Preliminary Staff Assessment

BLYTHE ENERGY PROJECT PHASE II

Application For Certification (02-AFC-1)
Riverside County

STAFF REPORT

TRANSMISSION SYSTEM ENGINEERING - FIGURE 2

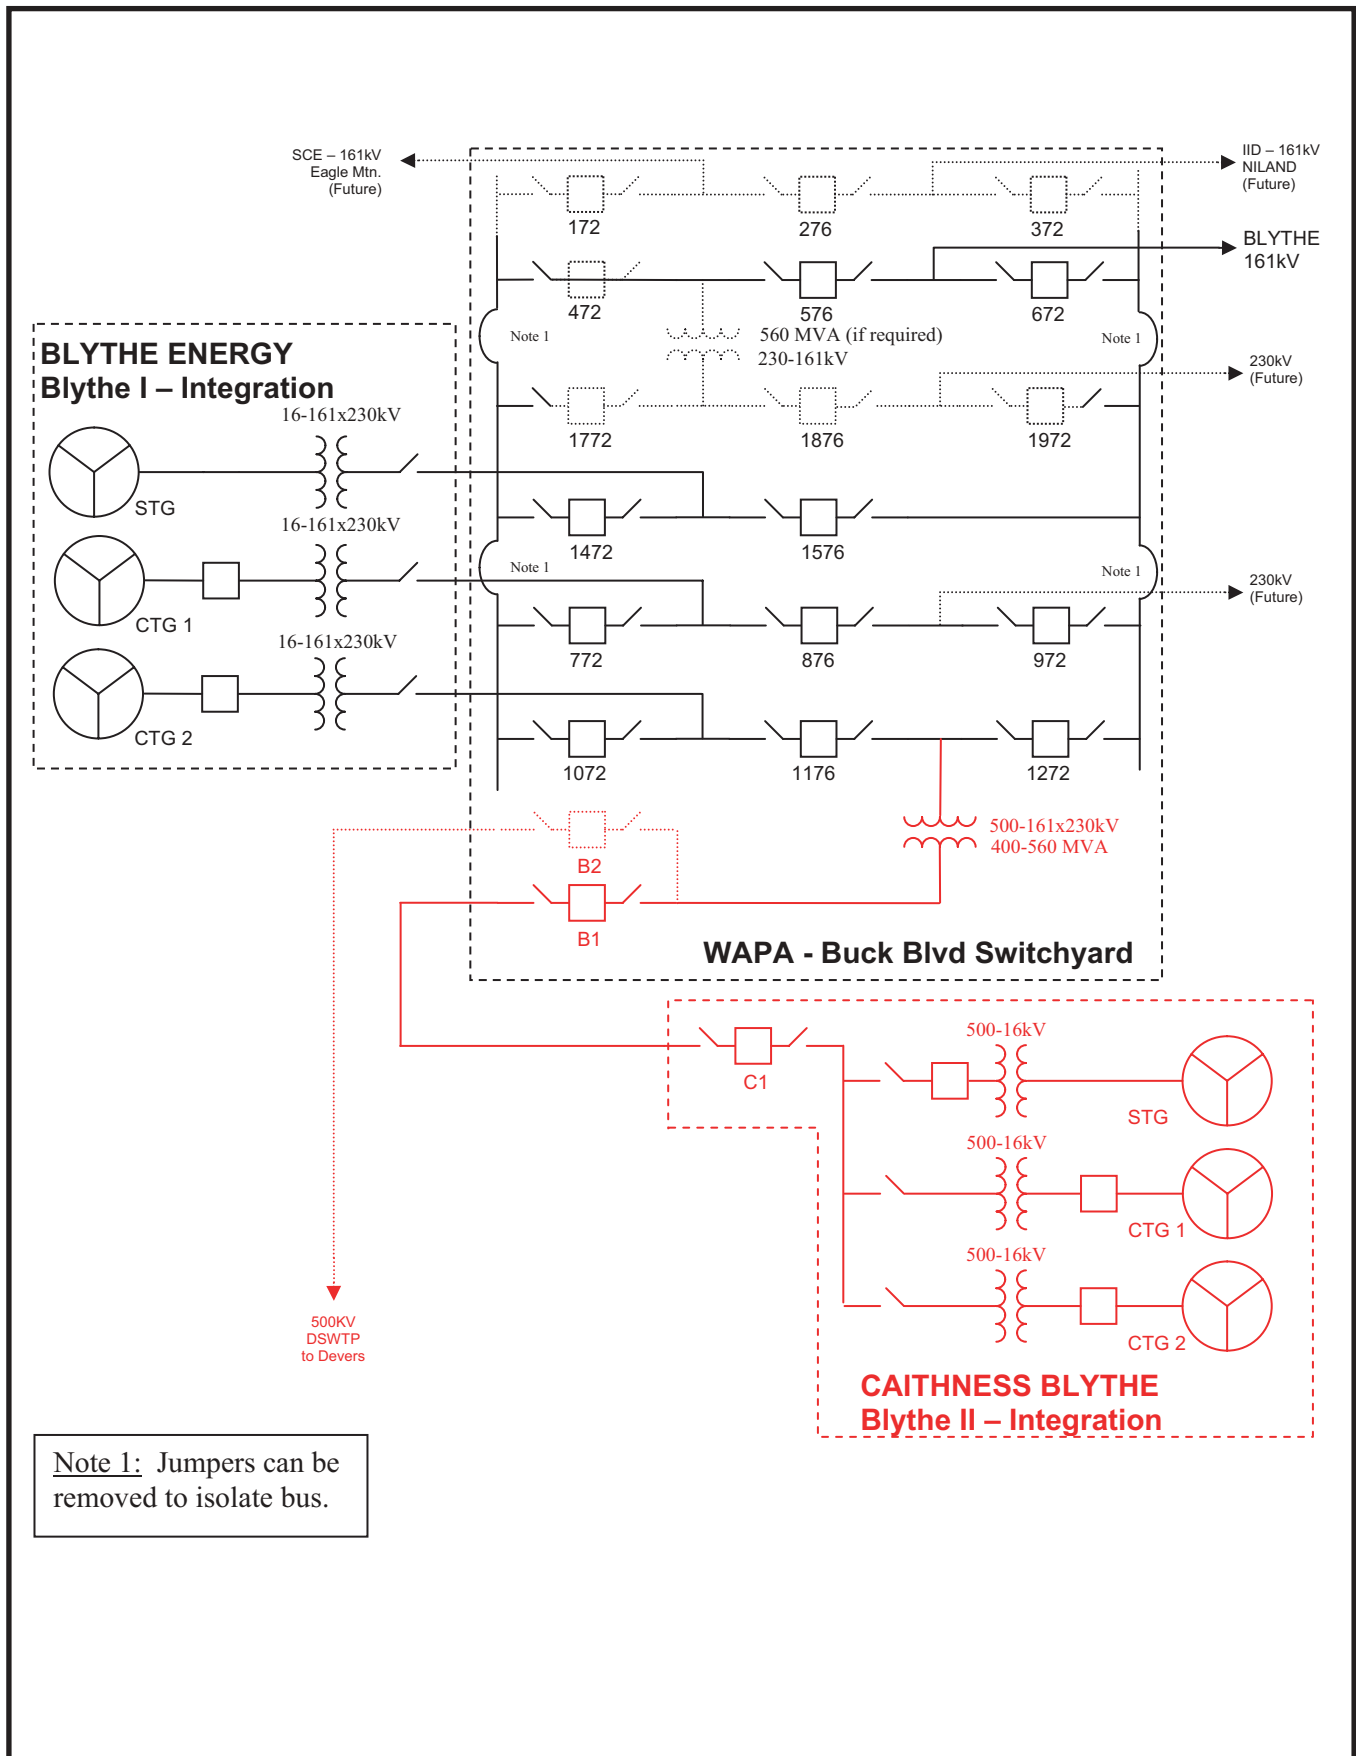
Approximately 8+ interconnection scenarios have been suggested by the applicant since filing the AFC. At the April 10, 2003 conference call, the applicant selected the TSE Figure 2 interconnection configuration for permitting purposes. Staff's analysis thus far analyzes only the TSE Figure 2 configuration and the above list of outstanding data pertains to that configuration. Staff has recently been informed by the Cal-ISO and

Staff has also concluded that the TSE Figure 2 interconnection configuration does not conform with LORS and the absence of a project definition and identification of transmission construction timelines indicates the BEPII is infeasible because it will not be able to deliver its power to the load.
